| BT27.50-P-0011-01A | Friction bearing in sun wheel of rear planet gear set converted to anti-friction bearing | Transmission 722.6 | k |

**TRANSMISSION 722.60# /61# /660 /662 /664 /665 /69# ## as of 1572721 as of 1.6.99, 722.62# /63# /650 /654 /661 /663 /666 /669 ## as of 1574575 as of 2.6.99**

P27.50-2046-11

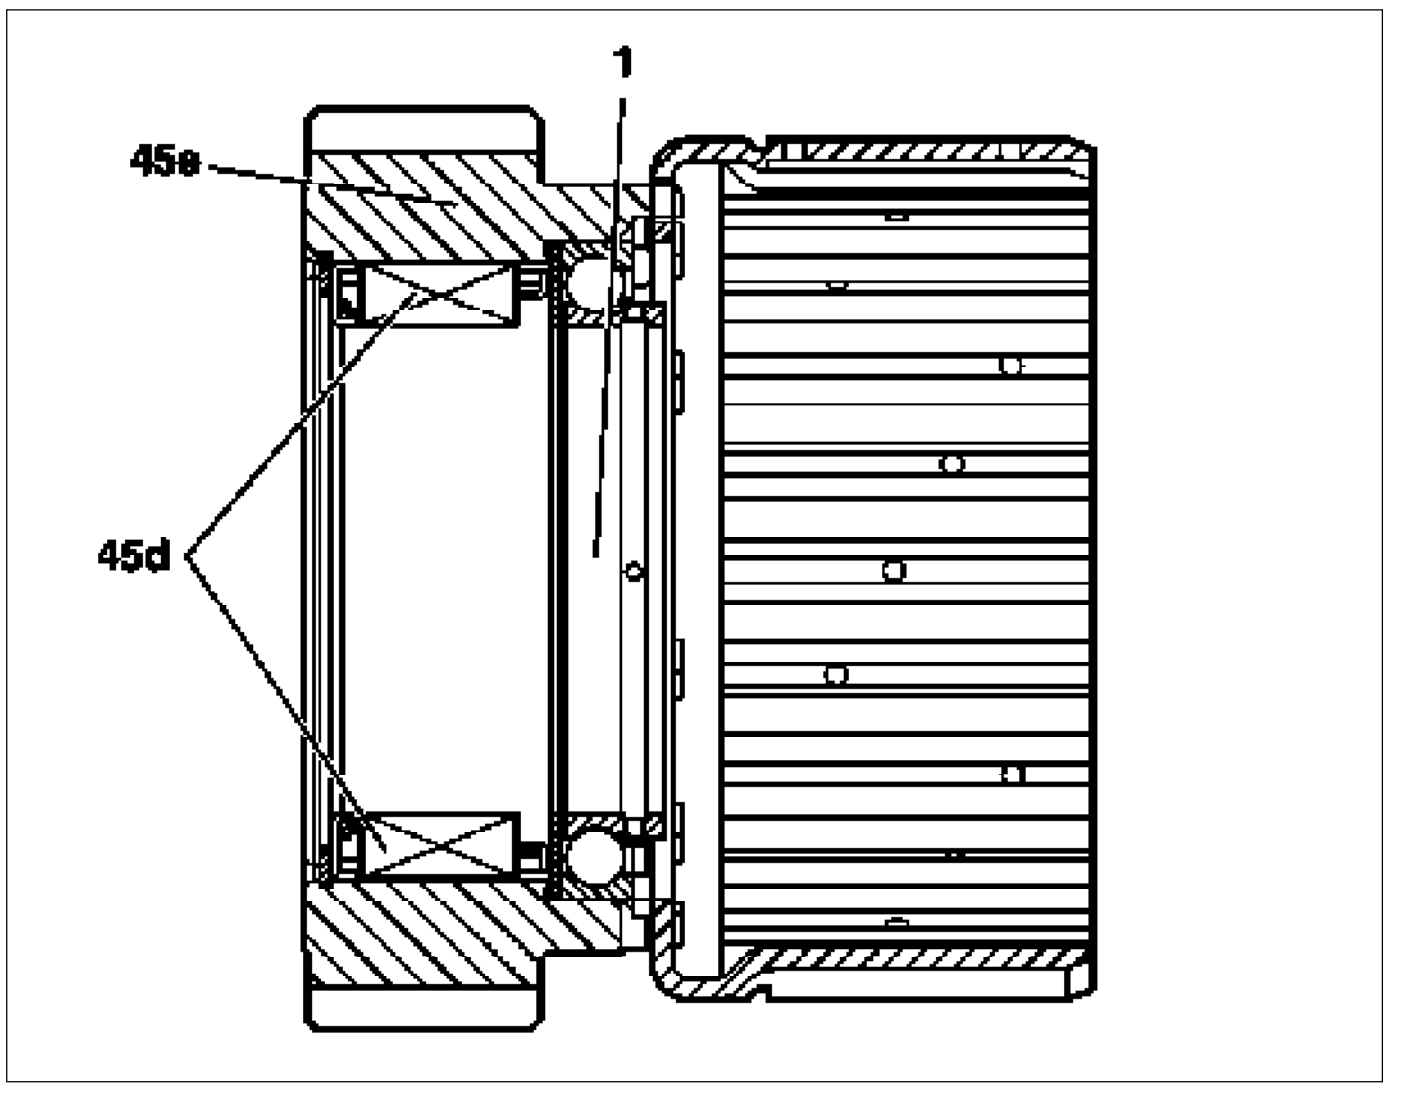
The friction bearing bush in the sun gear (45e) has been replaced with an anti-friction bearing (1).
This improves the bearing of the hollow shaft and the freewheel (45d) is no longer worn away by the friction bearing bush.
